PRODUCT ANNOUNCEMENT FROM MILLETEKNIK

DIN adapter has been updated.

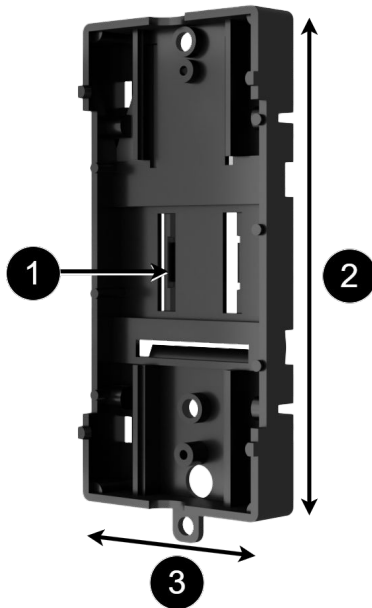
DIN adapter has received several updates:

1. Hooks for attachment to DIN rail have been improved and reinforced.
2. Stiffness has been reinforced. The length has increased by 0.5 mm to 89 mm.
3. The width has increased by 0.5 mm to 39.5 mm.

PCB slot size is identical.

The change does not affect the function of products DIN adapter fits.
